ASSESSMENT REPORT

1 Lawson Square, Redfern SSD 5249 MOD 3

Figure 8: Proposed northern façade of towers
(Source: Plans for MOD 3)

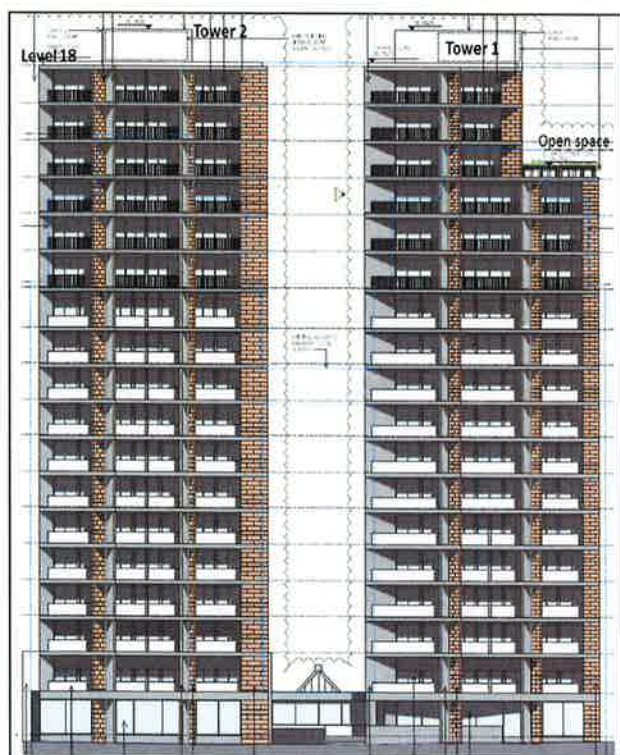
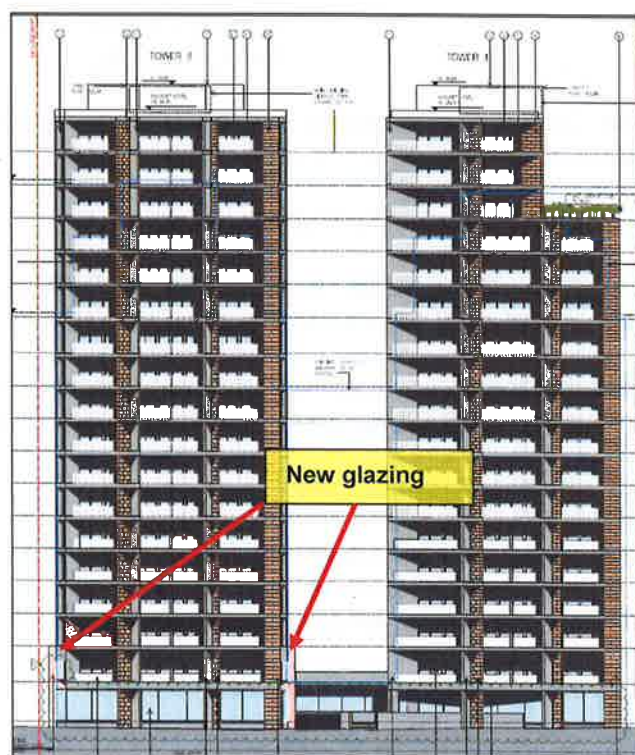
The changes to the north façade are limited to the ground and first floor commercial levels of Tower 1 which would replace some glass reinforced concrete with glazing (**Figures 7 and 8**). The amendments would not change the strong vertical expression of the tower's northern facade nor its material proportions of marble and off-form concrete. The changes to the northern façade of Tower 1 are therefore supported.

Figure 10: Proposed eastern and western elevation of Tower 1 (Source: Plans MOD 3)

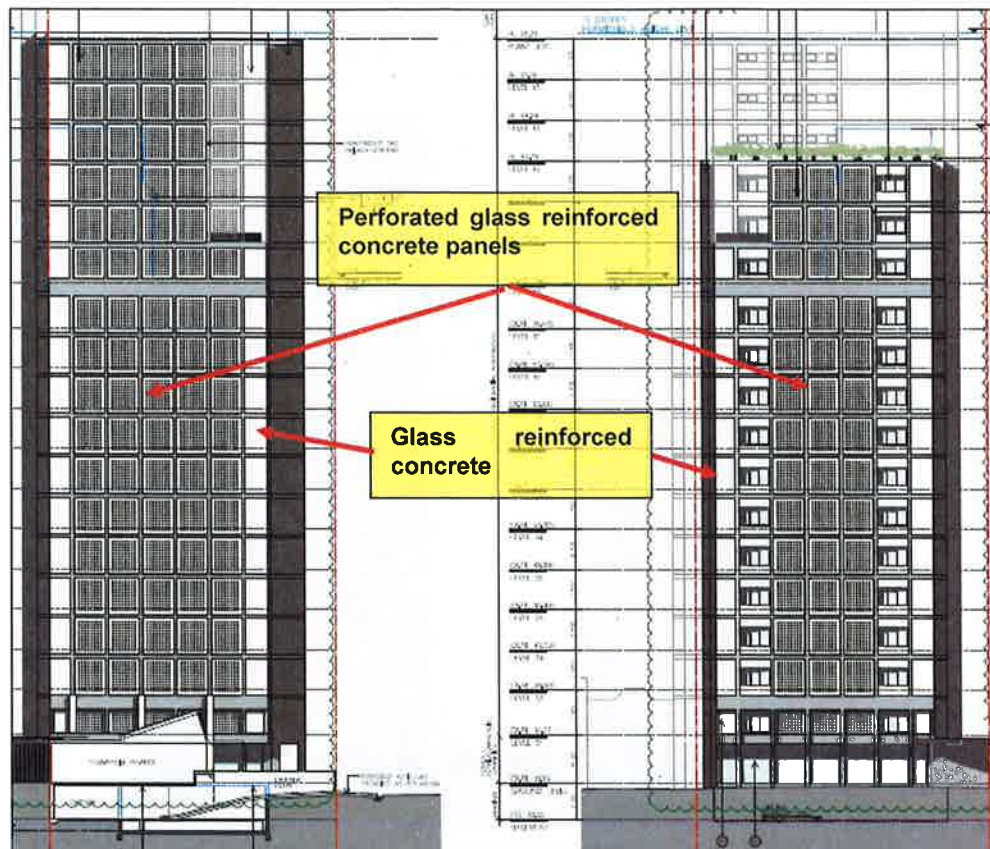
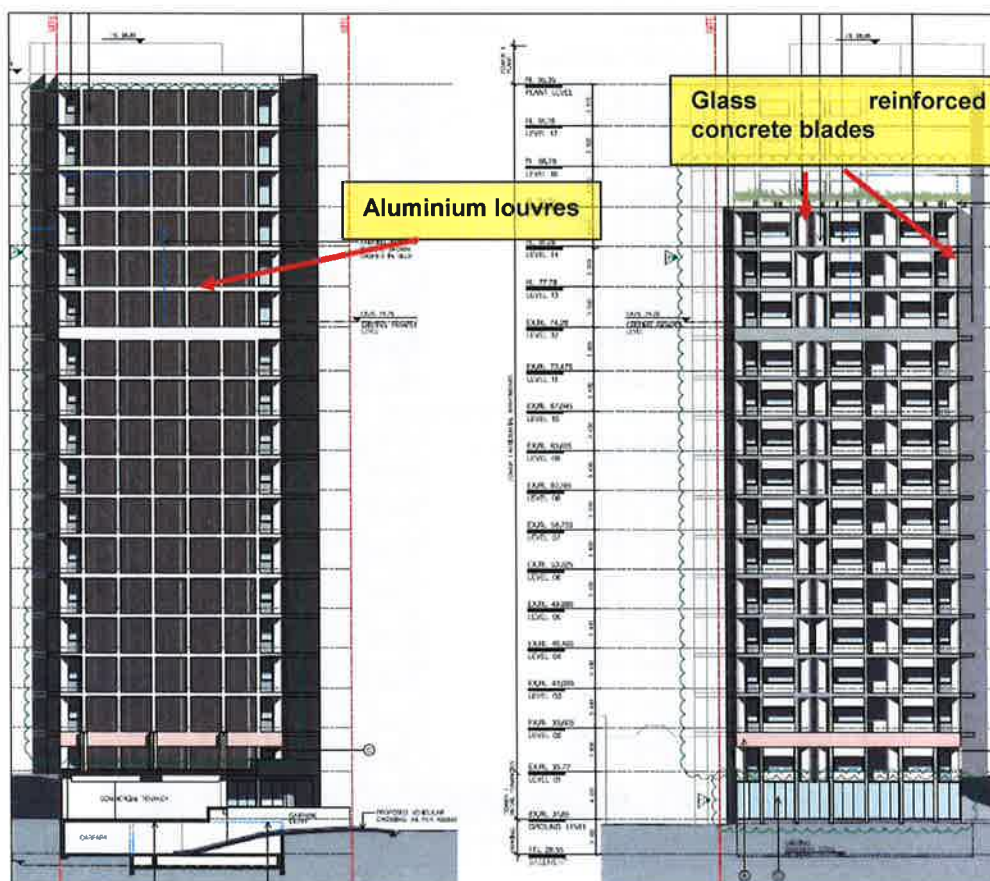
The approved perforated glass reinforced concrete screens are proposed to be replaced with glass reinforced concrete blades and aluminium louvres on the eastern and western facades of both of the towers (**Figures 9 and 10**). The changes would open up the facades of the towers and improve the internal amenity of the apartments by providing additional sunlight and views. The Department considers the changes to the towers would provide greater articulation and improved architectural expression and are therefore supported.

Figure 12: Proposed southern elevation of Towers 1 and 2
(Source: MOD 2)

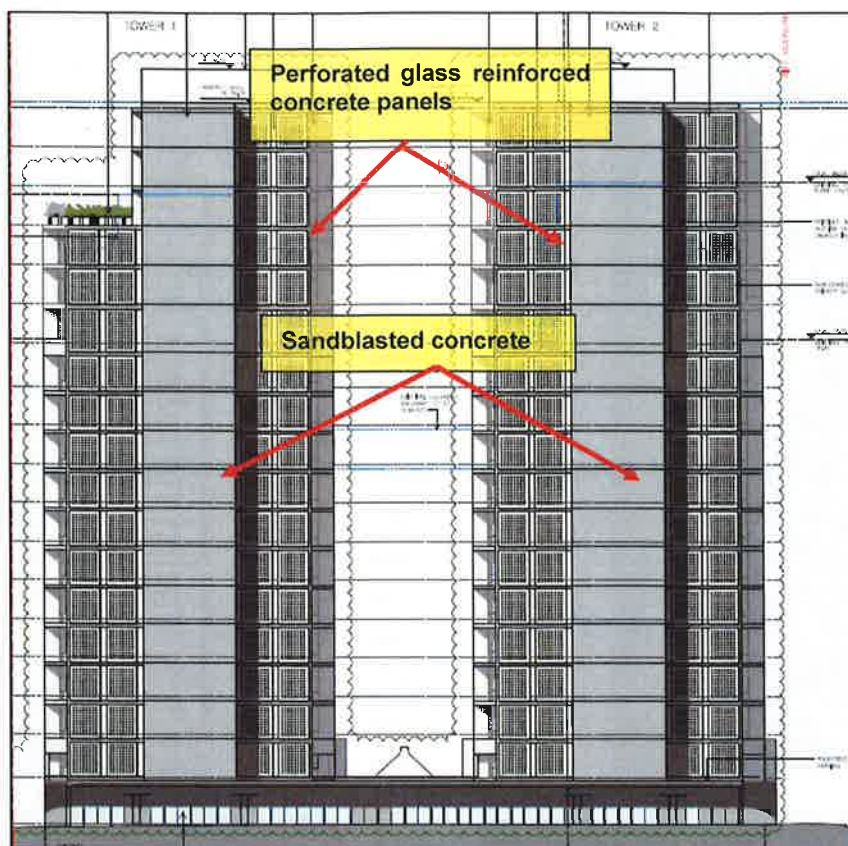
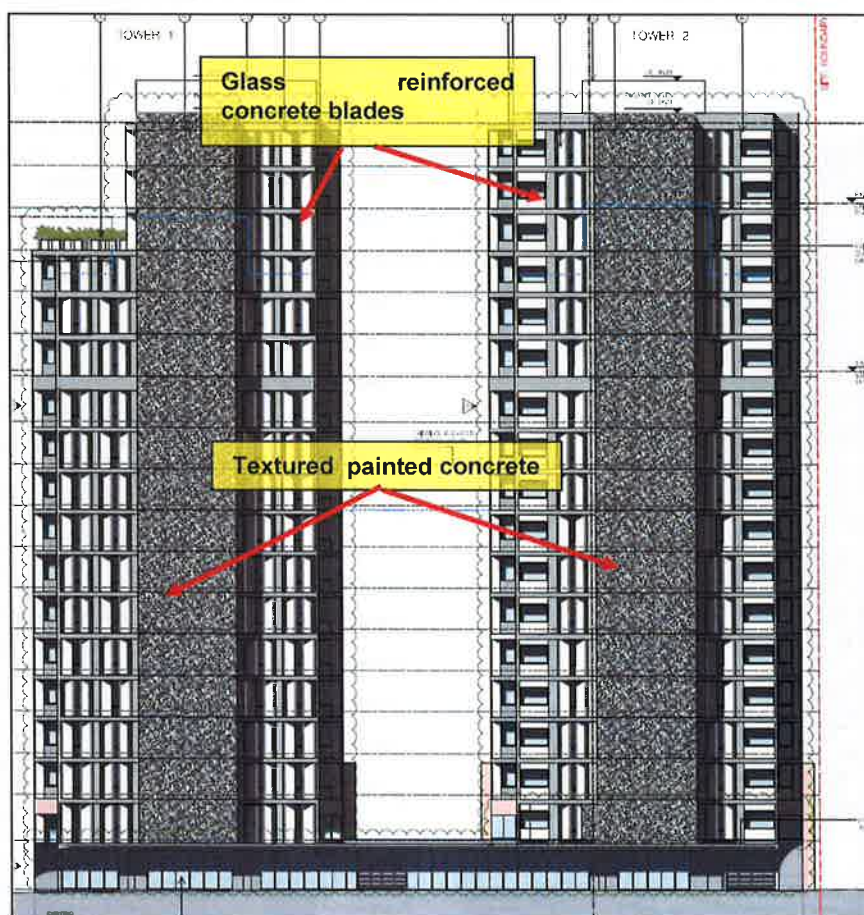
On the southern façade of the towers, the perforated glass reinforced concrete panels and sandblasted concrete would be replaced by glass reinforced concrete blades, glazing and textured painted concrete respectively (**Figures 11 and 12**). The Department considers the removal of the glass reinforced concrete panels would improve the articulation of the southern facades of the towers and provide greater vertical expression. This would act to reduce the façade's massing and improve the towers' proportions and visual appearance. The replacement of the sandblasted concrete with a textured maintained concrete would complement the overall palette of materials and maintain the overall aesthetic quality of the towers.

Figure 13: View lines between Tower 1 and 157 Redfern Street (Source: EIS for MOD 3)

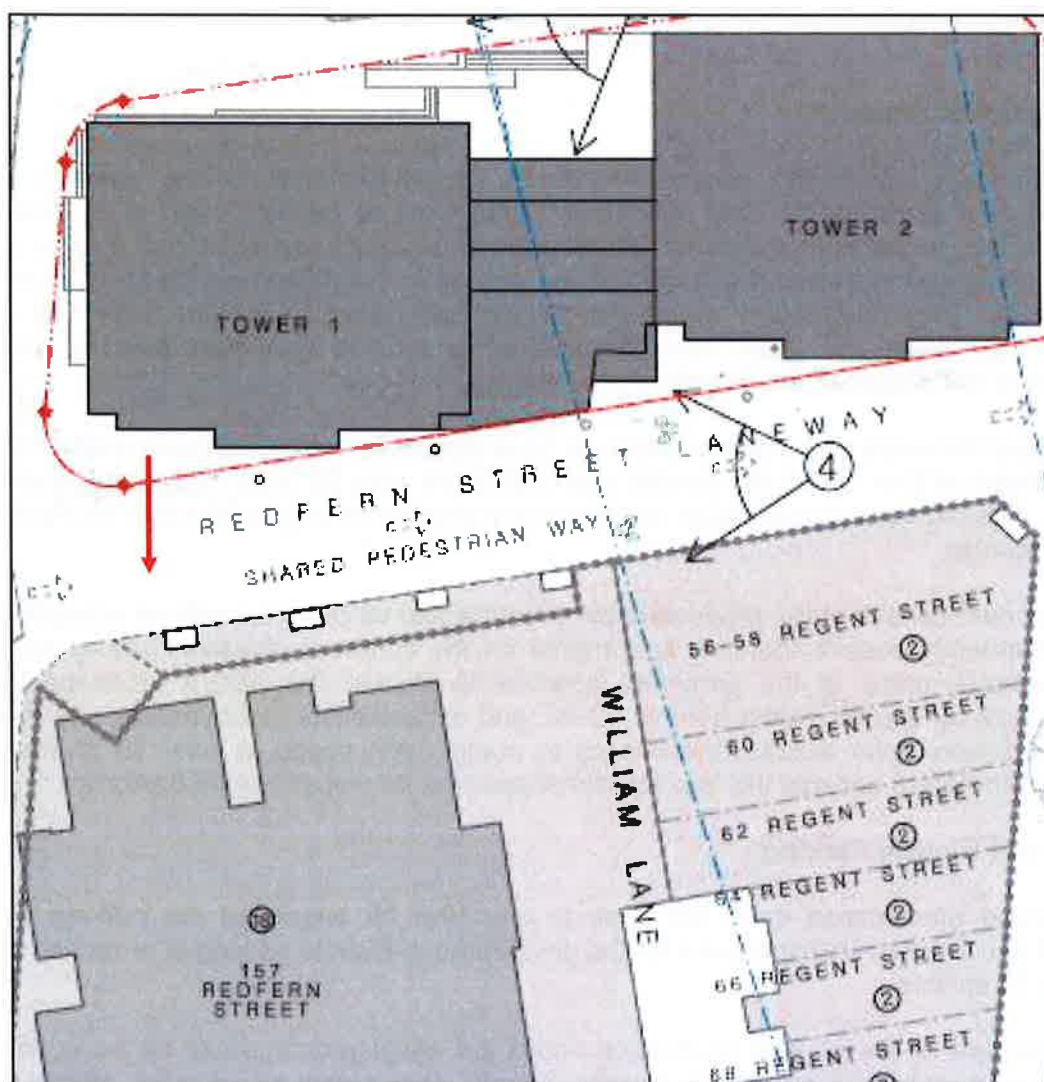
The modification seeks to remove the perforated glass reinforced concrete panels which face the southern residential apartment building at 157 Redfern Street. A public submission was received regarding privacy impacts from the south-facing windows of the western tower (Tower 1) to the north-facing apartments of 157 Redfern Street. The public submission raised concerns about the apartments in Tower 1 having bedrooms, living rooms and kitchen windows located to the south which would increase the potential for overlooking between the southern façades of Tower 1 and 157 Redfern Street.

The view lines between Tower 1 and 157 Redfern Street are identified at **Figure 13** below.

The Department considers the use of glass reinforced concrete blades and aluminium louvres which are appropriately glazed and angled, ensure that a reasonable level of privacy would be maintained to the adjacent residents at 157 Redfern Street. Additionally, the changes proposed to the layout of apartments on the southern elevation would ensure that living areas are orientated away from the south to mitigate overlooking potential. The Department further notes the residents at Tower 1 and 157 Redfern Street are separated by approximately 17.1 m which also mitigates overlooking potential.

The Department concludes the proposed development would maintain acceptable levels of privacy to the residents of 157 Redfern Street.
